PROPOSED TECHNICAL SPECIFICATIONS CHANGES
NORTH ANNA UNIT 1

VIRGINIA ELECTRIC AND POWER COMPANY

DISCUSSION OF PROPOSED CHANGES

SAFETY EVALUATION

Figure 2.1-1a REACTOR CORE SAFETY LIMITS FOR THREE LOOP OPERATION FOR THE PERIOD OF OPERATION UNTIL STEAM GENERATOR REPLACEMENT

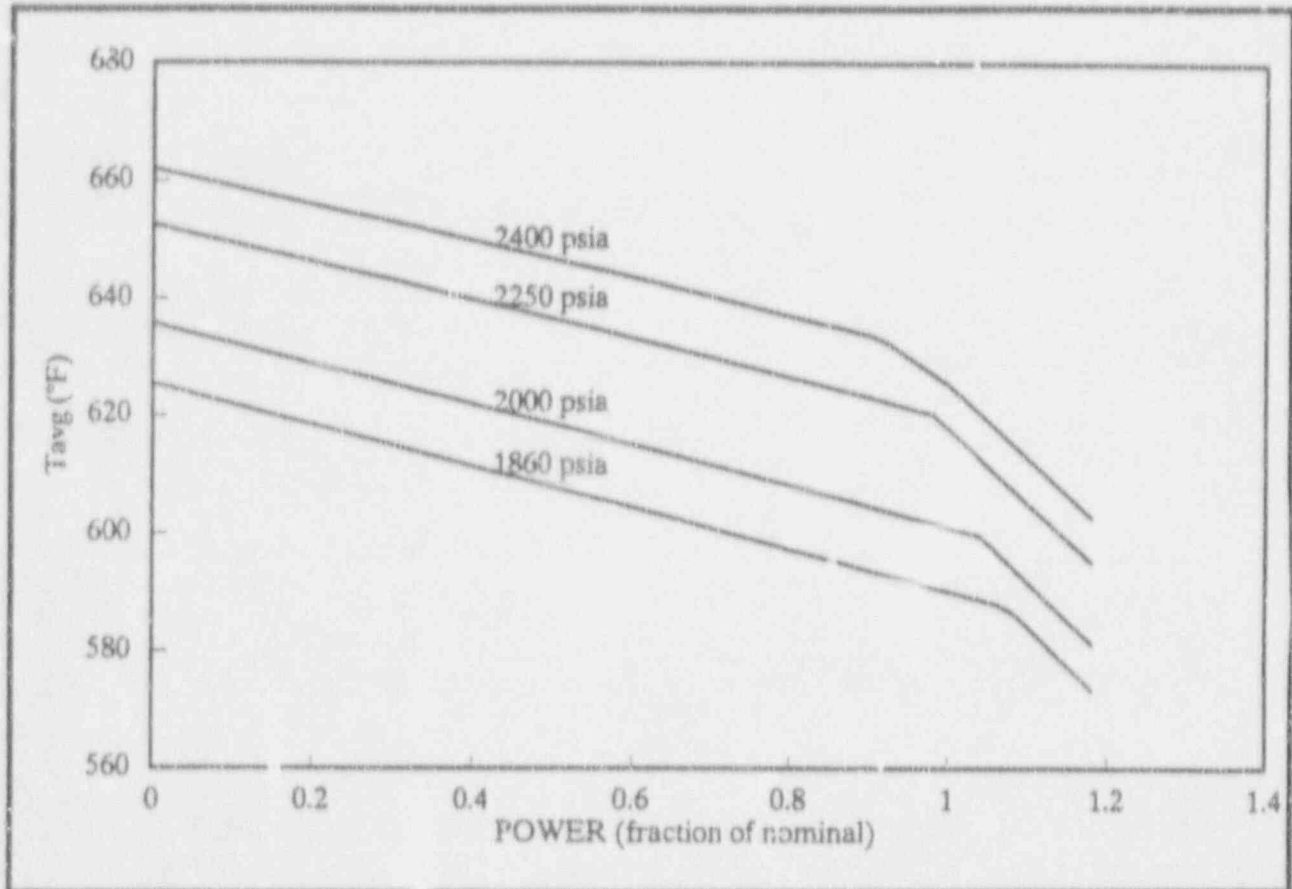
* For the period of operation until steam generator replacement, the combination of THERMAL POWER, pressurizer pressure, and the highest operating loop coolant temperature (T_{avg}) shall not exceed the limits shown in Figure 2.1-1a.

The proposed Technical Specifications changes will revise Technical Specification 2.1.1 by placing a footnote on the bottom of the page referencing Figure 2.1-1a in lieu of Figure 2.1-1 for the Reactor Core Safety Limits. A revised reactor core safety limits graph (Figure 2.1-1a) is added with the inclusion of a new page - 2-2a. The graph is changed to reflect the 268,500 gpm flow limit at 95% of Rated Thermal Power. Both the footnote and the graph title are worded to be effective for the period of operation until steam generator replacement.

FIGURE 1
CORE THERMAL LIMITS

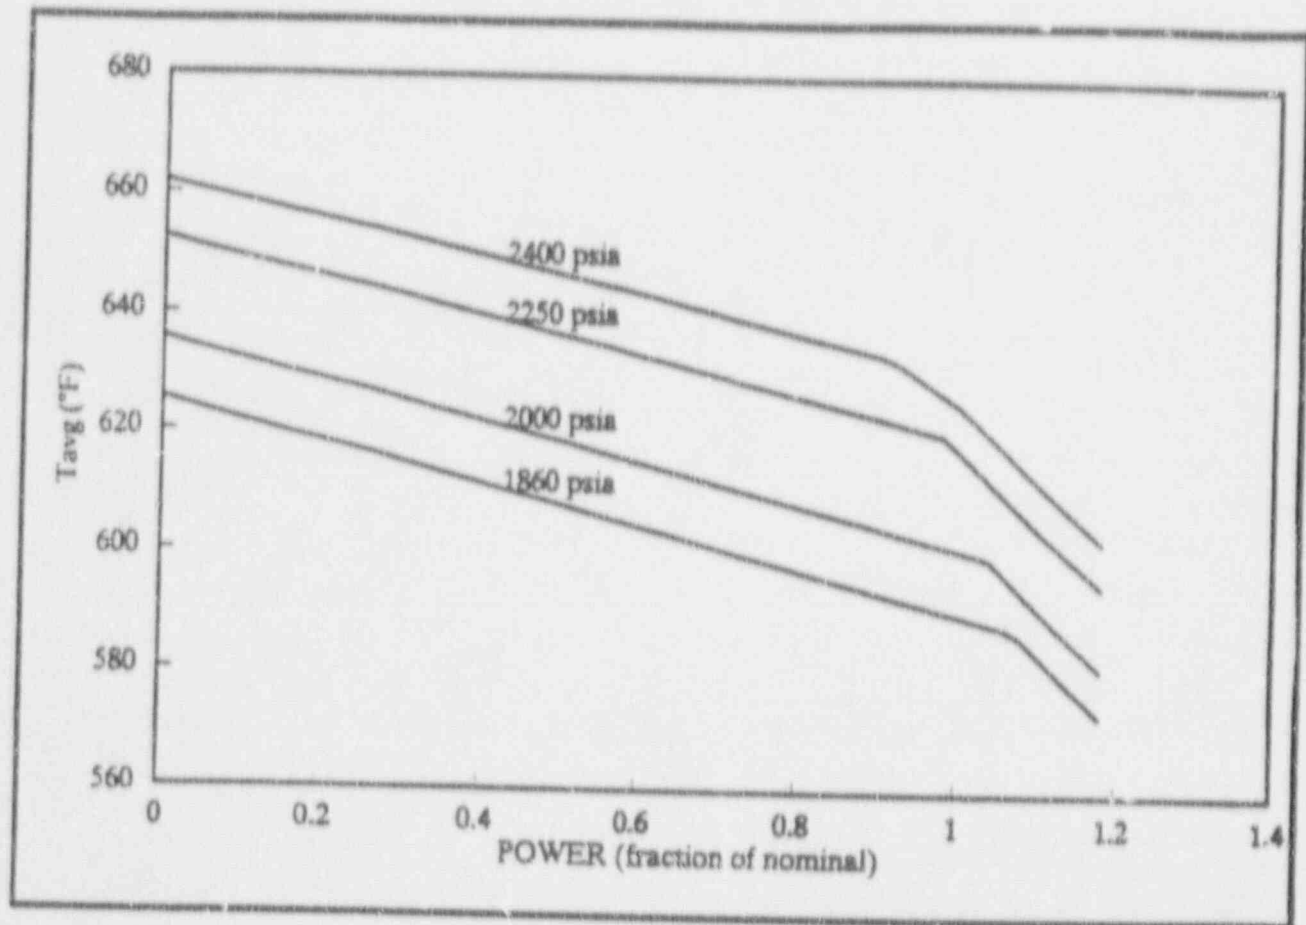
For the proposed additional reduction in minimum measured RCS flow rate to 268,500 gpm, revised thermal limit lines have been generated based on this reduced flow and a design DNBR limit of 1.46. In this way, no flow reduction penalty need be assessed against the generic retained DNBR margin for operation at 268,500 gpm. The definition and application of retained DNBR margin in Virginia Power design analyses is described in References 1 and 2.

The vessel exit boiling limited portions of the core thermal limits were evaluated with the proposed reduced non-statistical (deterministic) thermal design flow rate of 263,130 gpm (which corresponds to a minimum measured flow rate limit of 268,500 gpm). The revised Thermal Limits are shown in Figure 1.

FIGURE 2

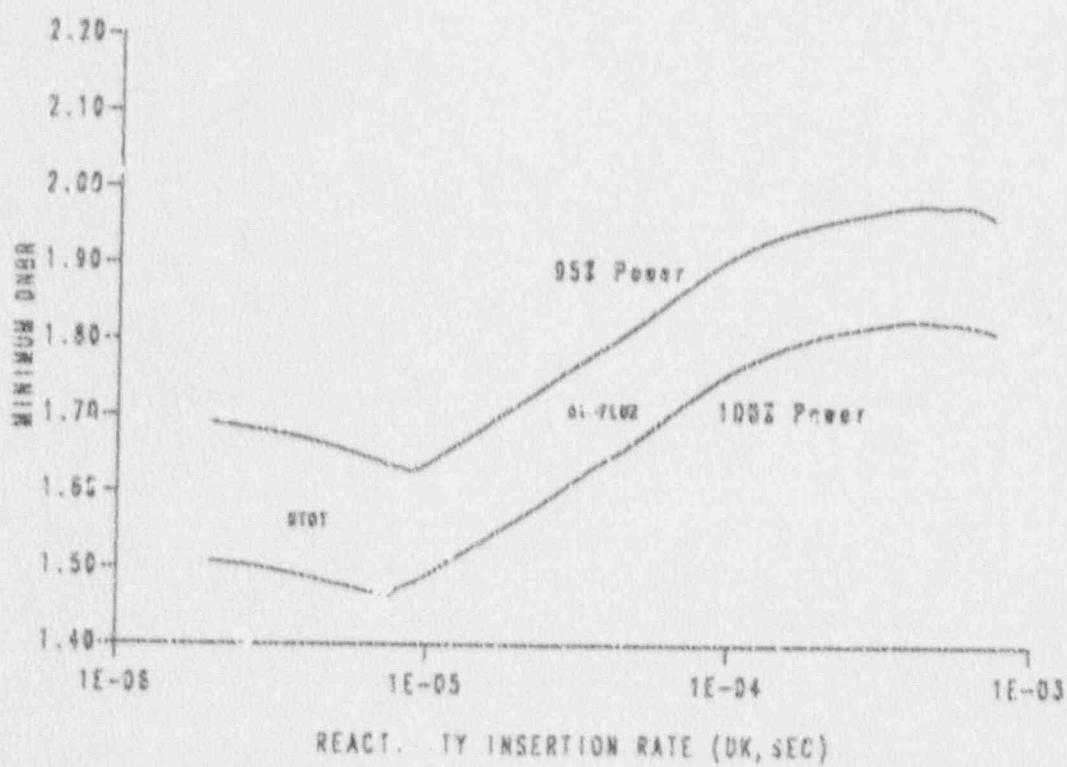
The reanalysis of the rod withdrawal at power event demonstrated that the minimum DNBR will remain above the DNBR design limit for operation with reduced minimum measured flow associated with extended steam generator tube plugging.

Figure 2, on the following page, presents the minimum RWAP DNBR result as a function of reactivity insertion rate. The lower graph (labelled 100% Power) shows the Ref. 1 analysis results assuming the 275,300 gpm minimum measured flowrate, 100% power and the current Technical Specification OTAT setpoints. The upper graph (labelled 95% power) shows the results from the revised analysis with reduced minimum measured flowrate, 95% power, the proposed Technical Specification OTAT setpoints, and a reduction in the power range high flux trip setpoint. These results demonstrate that the combination of Overtemperature ΔT and high flux reactor trips act together to provide core DNB protection over the range of achievable thermal conditions.
